Reference: Manor Oak Homes Planning Application (2023/5978/EIA)

Re: Grange Park Parish Council's response to:

- **MAC Technical Note – LLFA Response (476-TN-01-A August 2024)**
- **Grange Park Statement in Support of Recreational Provisions v1 SR 220724 (Nicholsons)**

3. Inadequate Location Site Plan

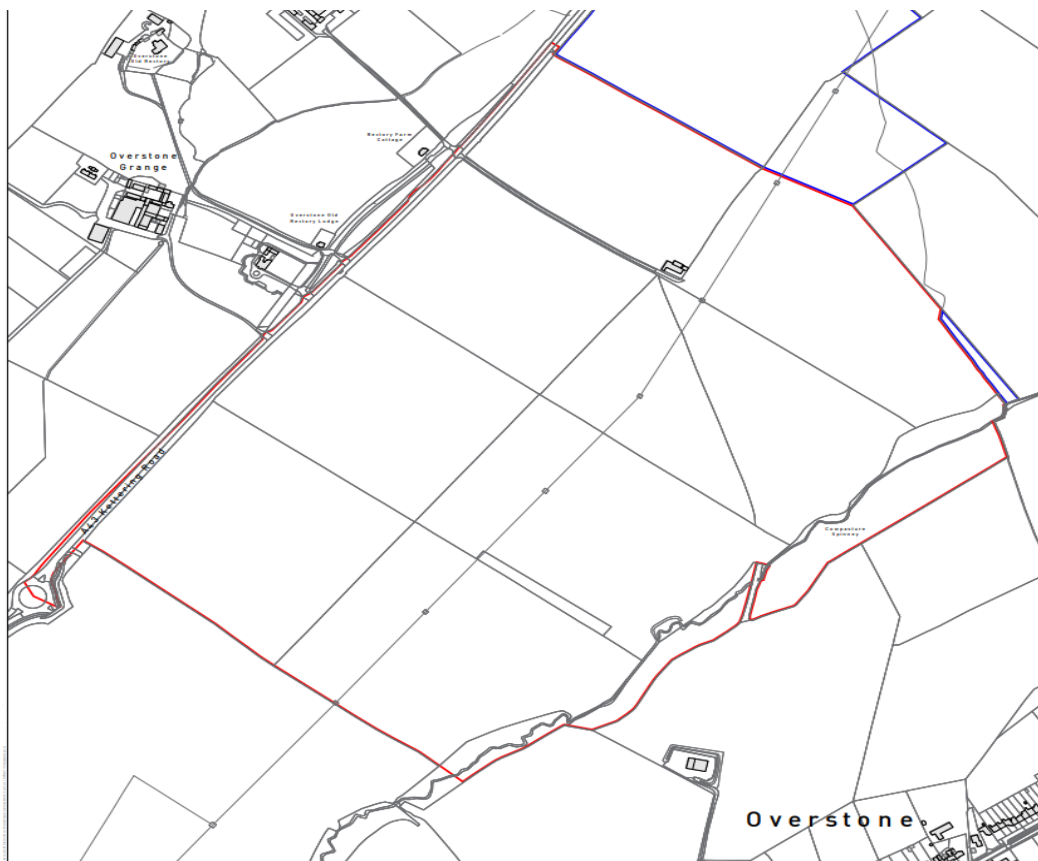
As stated above, the off-site works have not been assessed the same as on-site work. Subsequently all consultants have no assessment information on the off-site changes and the impact of these.

How can you consider something without assessment? The off-site changes are pivotal for this proposed application and need to be assessed as part of the planning application process and not part of conditions of a Section106.

The GOV UK website states, “The application site should be edged clearly with a red line on the location plan. It should include all land necessary to carry out the proposed development (eg land required for access to the site from a public highway, visibility splays, landscaping, car parking and open areas around buildings). A blue line should be drawn around any other land owned by the applicant, close to or adjoining the application site.”¹

The Site Location Plan submitted by Manor Oak Homes does not comply with the above requirements. Manor Oak Homes should be required to submit a Site Location Plan, where proposed off site changes which are necessary for the proposed development, are included within the red line of the planning application. The land would then be subject to the assessments on trees, hedgerow, ecology, landscape impact, drainage and road safety assessment.
